REGULATORY INFORMATION DISTRIBUTION SYSTEM (RIDS)

SUBJECT: Application for amends to Licenses NPF-41, NPF-51 & NPF-74,  
 revising TS to allow implementation of guidance provided in  
 Generic Ltr 89-01, "Implementation of Programmatic Controls  
 for Radiological Effluent TS in Administrative Controls...."

**Subject: Palo Verde Nuclear Generating Station (PVNGS)**  
**Units 1, 2, and 3**  
**Docket Nos. STN 50-528/529/530**  
**Technical Specification Amendment Request**  
**Implementation of Generic Letter 89-01**  
**File: 92-F-005-419.05; 92-056-026**

FIGURE 5.1-2

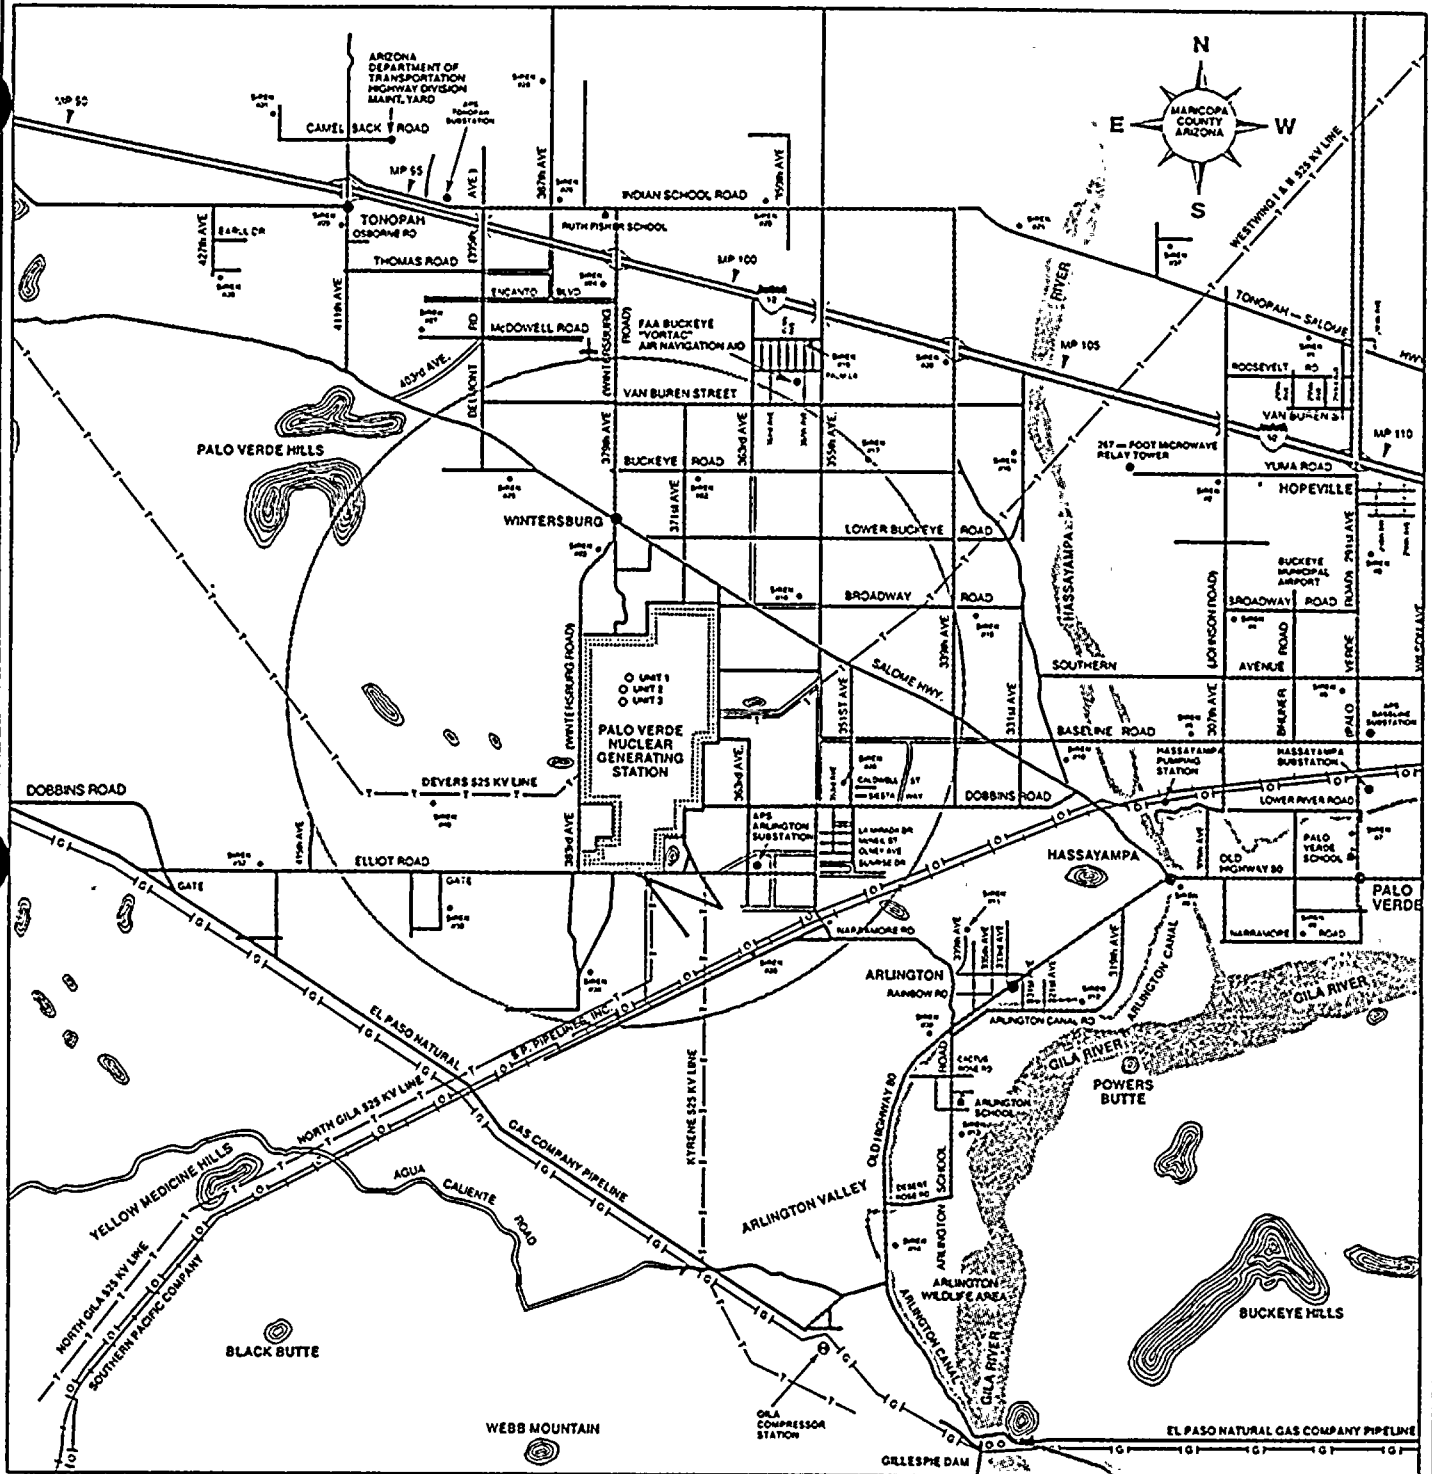
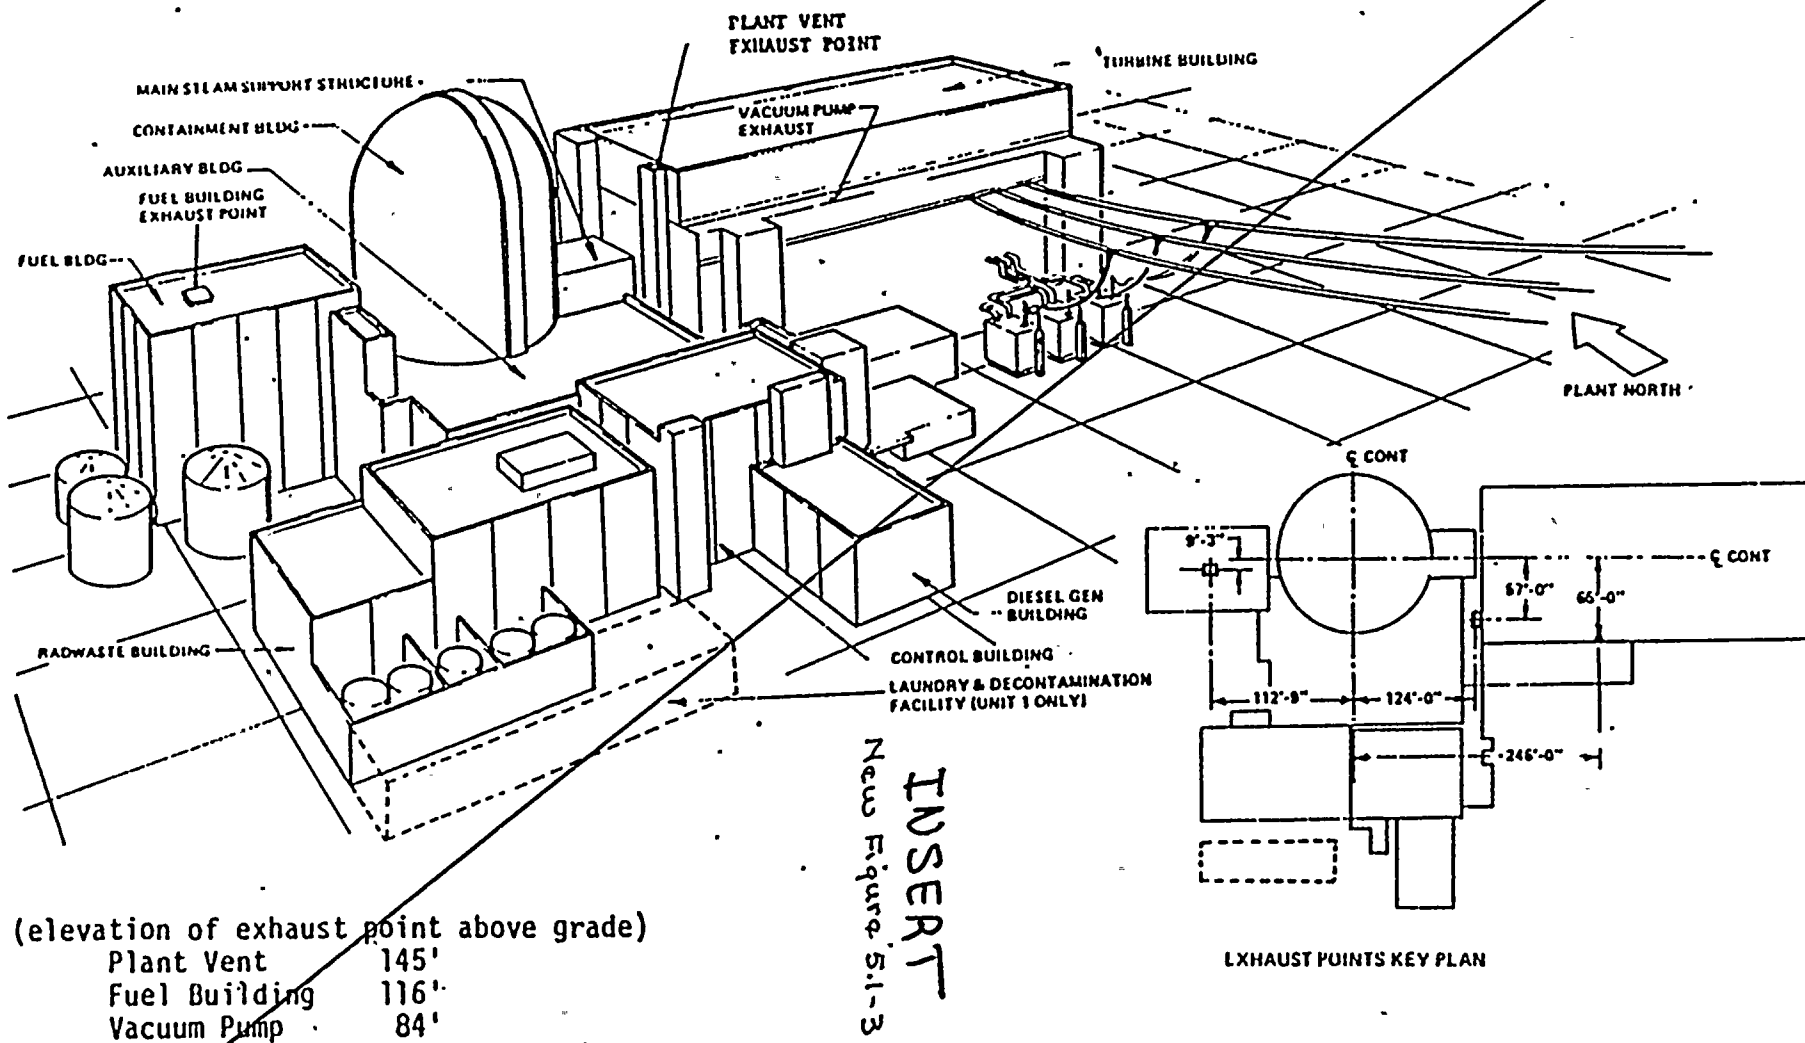
A second difference is that Figures 5.1-1, 5.1-2, and 5.1-3 have been enhanced. The revised figures provide information that is more clear than the existing figures. Figure 5.1-3 has additional changes: the fuel building exhaust is 100'-3" from center line of containment, not 112'-9"; and the elevation of the exhaust point above grade for the Condenser Vacuum is 109'-9" not 116'. These changes are administrative, i.e., the exhaust locations have not changed, and the original distances indicated were incorrect since issuance of the unit licenses.

New Figure 5.1-2

FIGURE 5.1-2

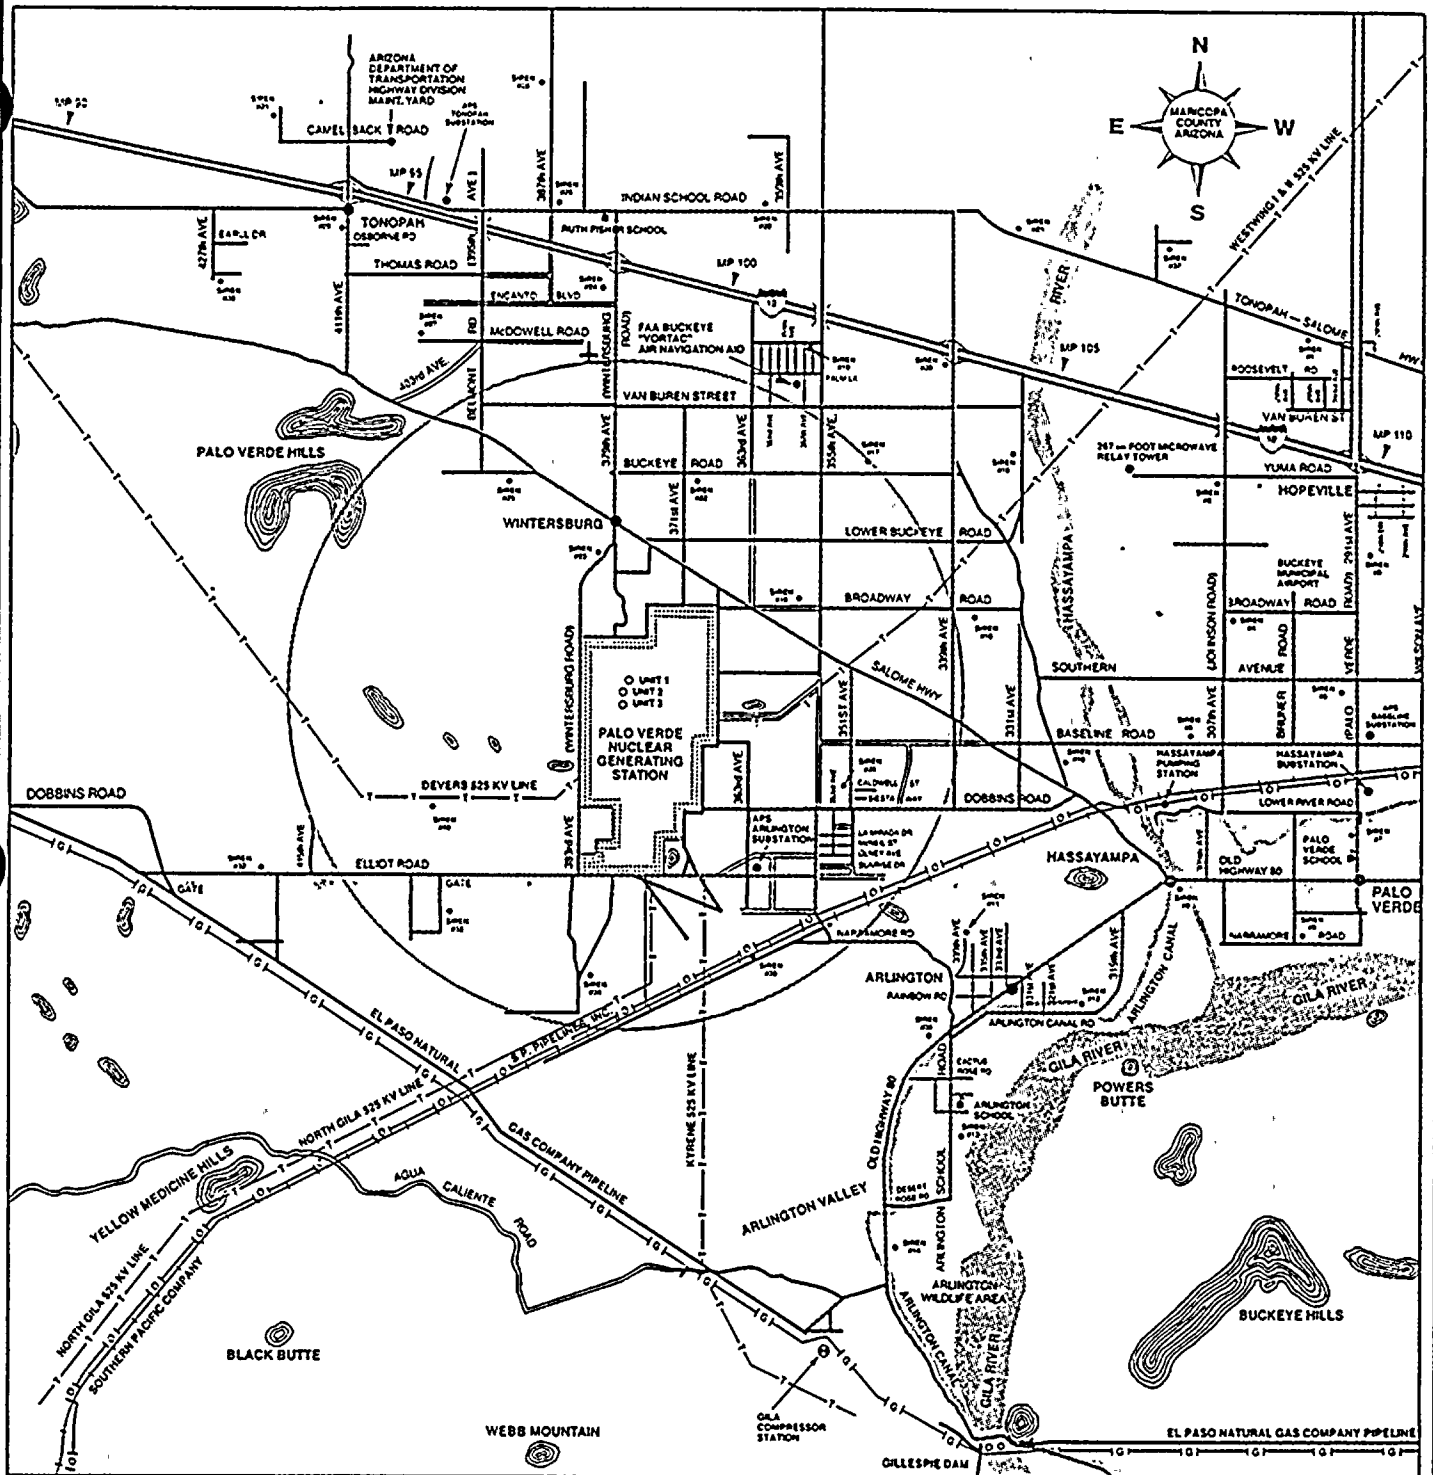
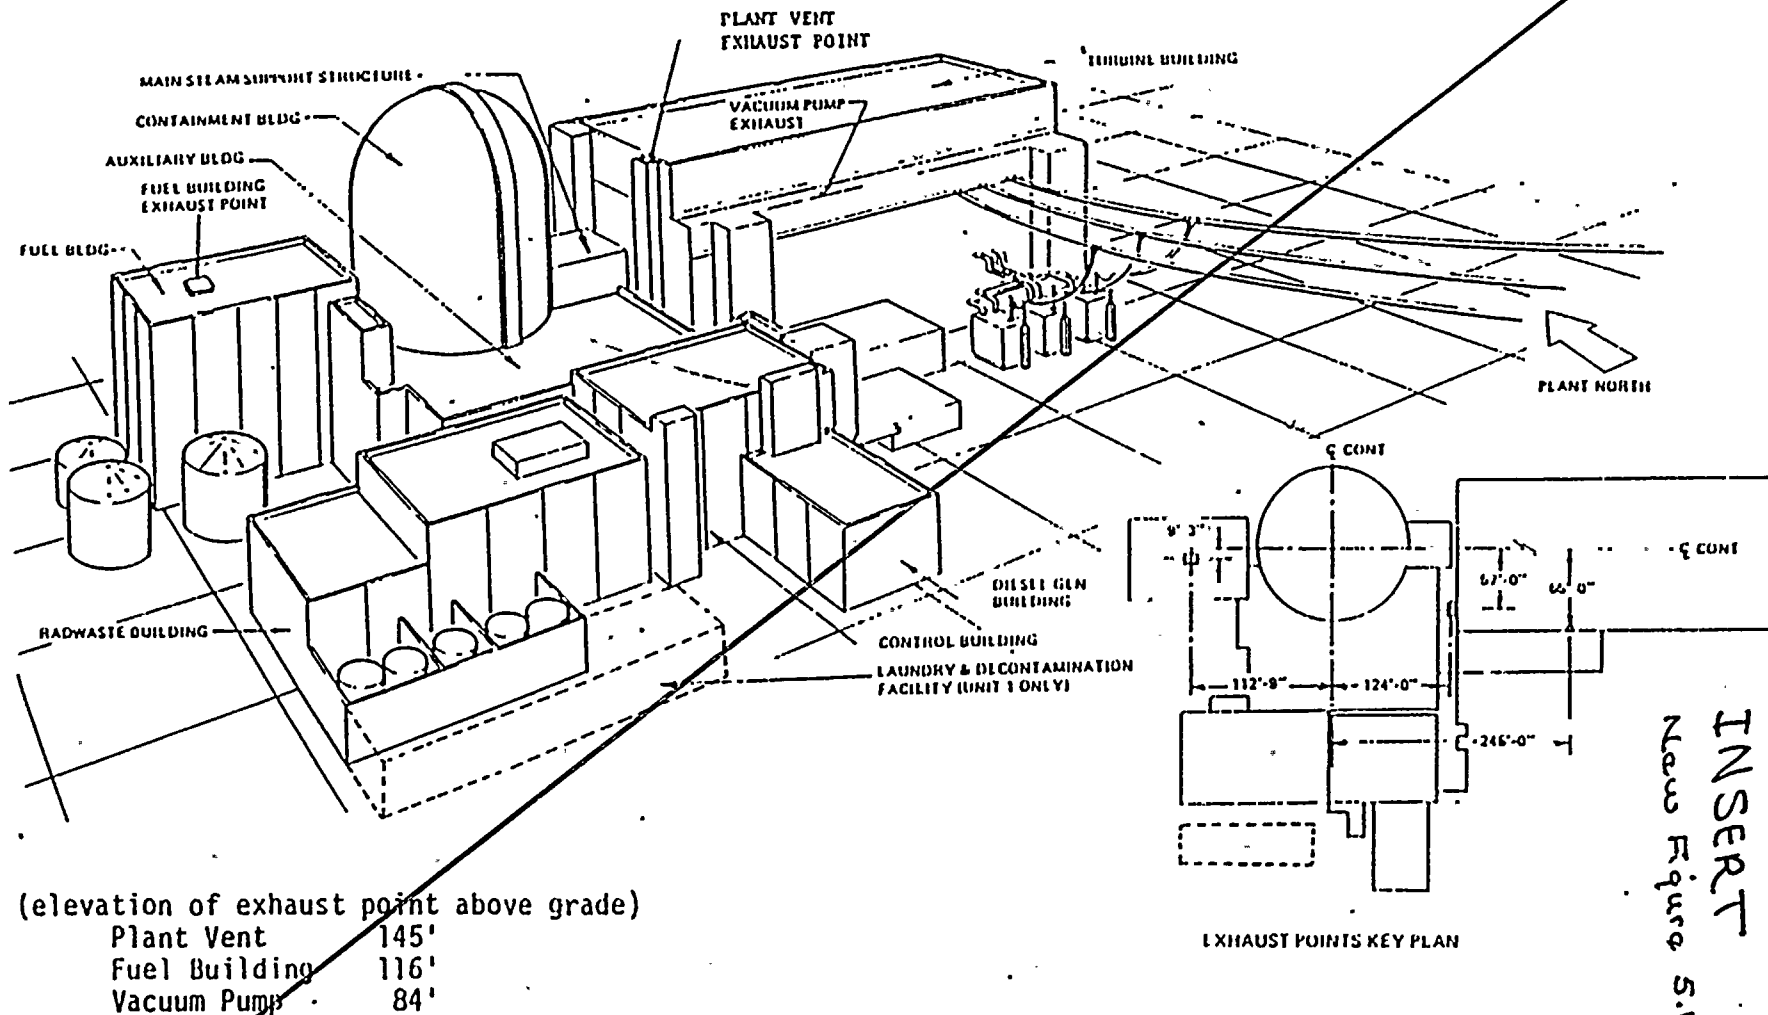
New Figure 5.1-2

FIGURE 5.1-3  
GASEOUS RELEASE POINTS

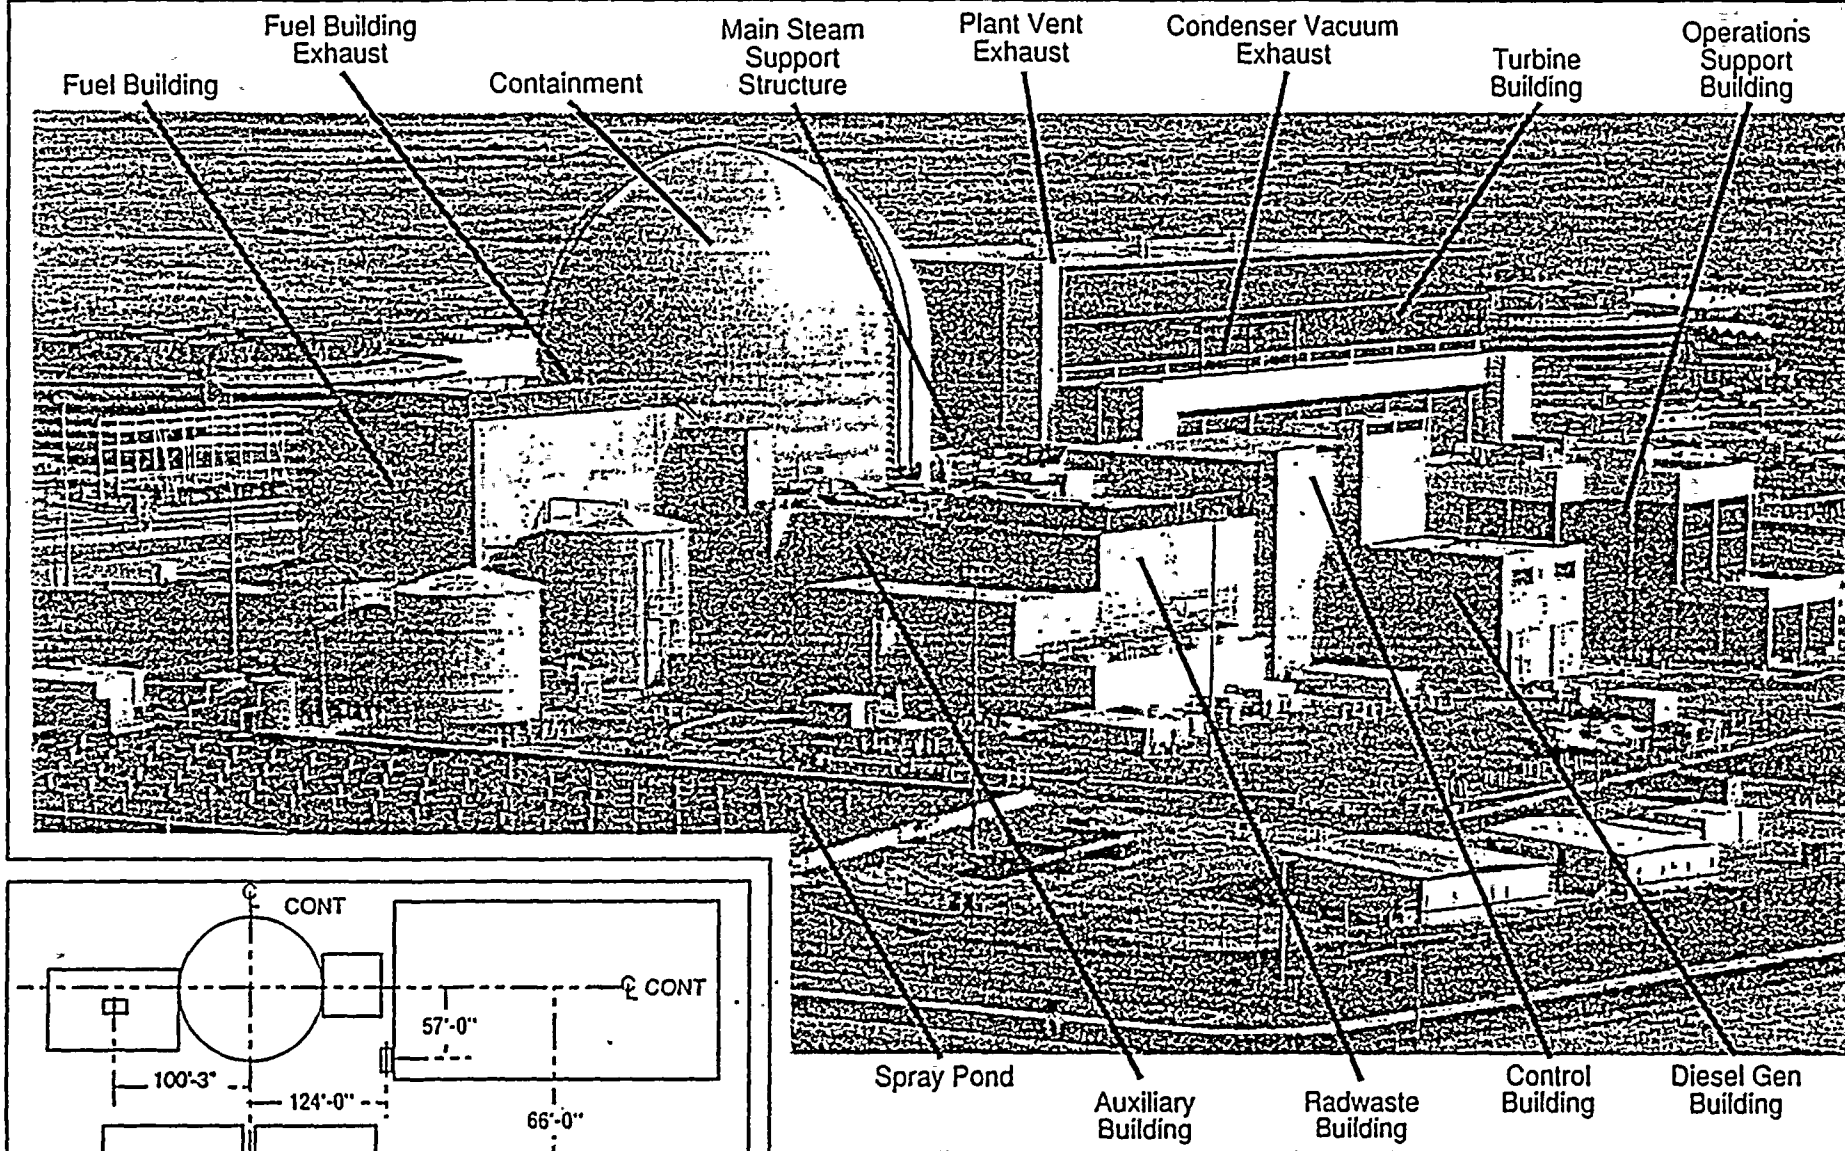
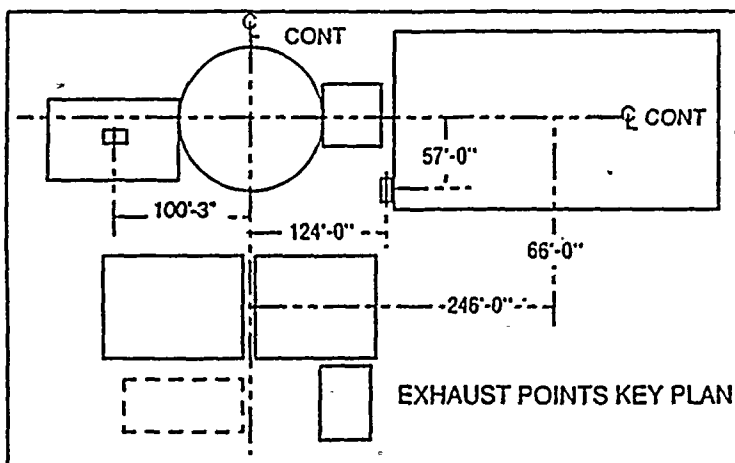
INSERT  
New Figure 5.1-3
